In re: KXCL(FM), Placerville, CA  
Facility I.D. No.: 36028  
Request for confirmation of compliance with  
47 C.F.R. § 73.1125

**Subject:** City grade coverage of main studio, KXCL-FM, Placerville, CA

IN RE: Request for confirmation that the proposed location of the main studio for KXCL(FM), Placerville, CA complies with 47 C.F.R. § 73.1125.

**FIRST BROADCASTING SACRAMENTO LICENSING, LLC  
STATION KXCL(FM)  
PLACERVILLE, CALIFORNIA  
CH 221A 6.0 KW(H&V) 100 METERS  
SUPPLEMENTAL SHOWING  
IN SUPPORT OF A  
REQUEST FOR FCC CONFIRMATION THAT  
PROPOSED MAIN STUDIO LOCATION  
COMPLIES WITH SECTION 73.1125**

# KXCL, Placerville, CA, Longley-Rice Propagation Model

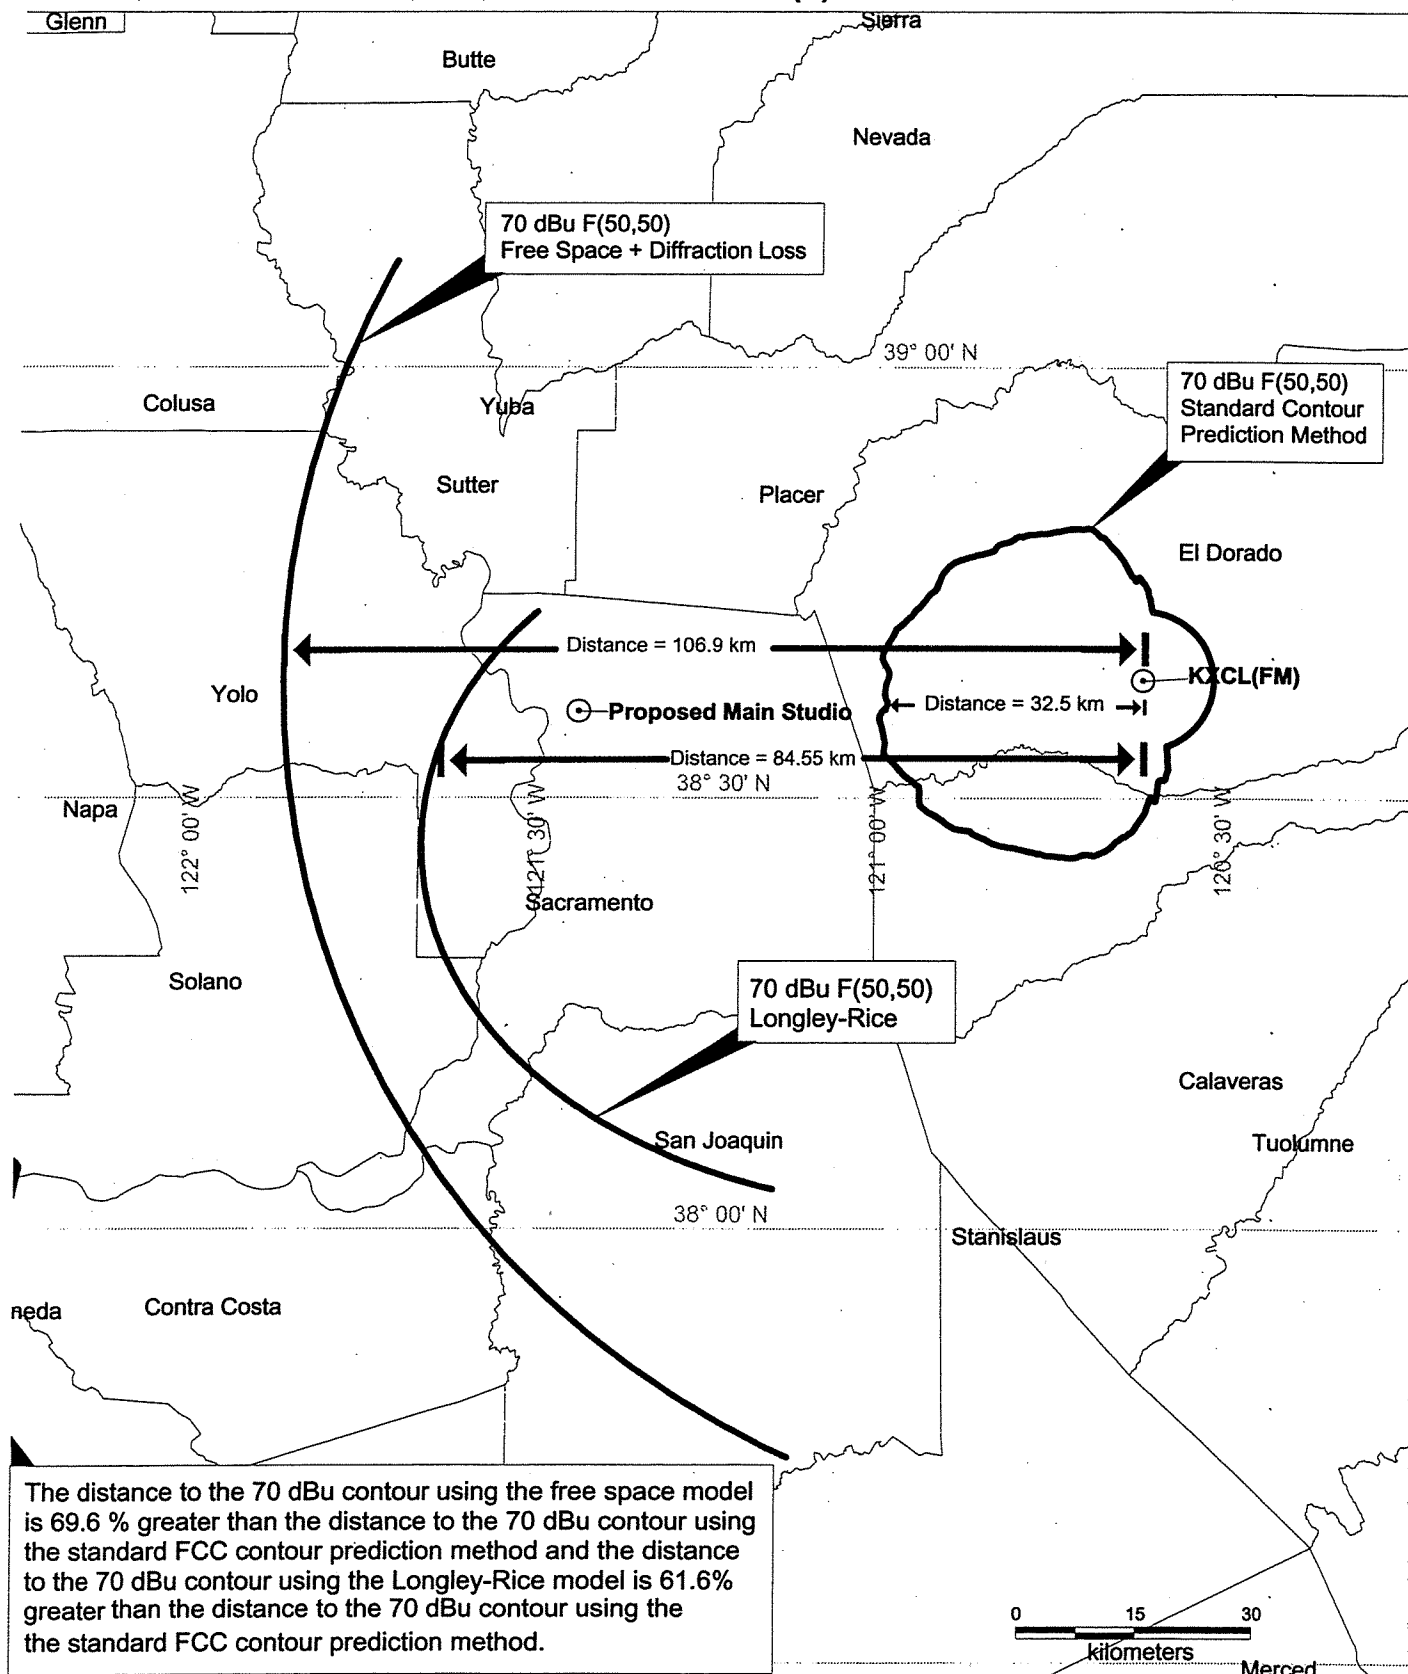
Our initial review of this supplemental showing revealed that in the direction of the main studio the 70 dBu field strength contour, as calculated using Longley-Rice and basic free space, extends beyond the 70 dBu field strength contour, as calculated by Commission rule § 73.313, by 62% and 70%, respectively, for KXCL. (By policy the extension must be ten percent or more for referral to you for analysis.) Because we cannot confirm compliance with § 73.1125(a) in this case, we request your assistance. Attached is a copy of the supplemental engineering showing. If you have any questions, please contact Rudy Bonacci at 418-2722.

By way of a Memorandum dated July 12, 2006, the OET confirmed that the proposed main studio location is encompassed by the 70 dBu field strength contour of the facilities specified in KXCL's license. Accordingly, we find that KXCL's proposed main studio location would be in compliance with 47 C.F.R. § 73.1125.
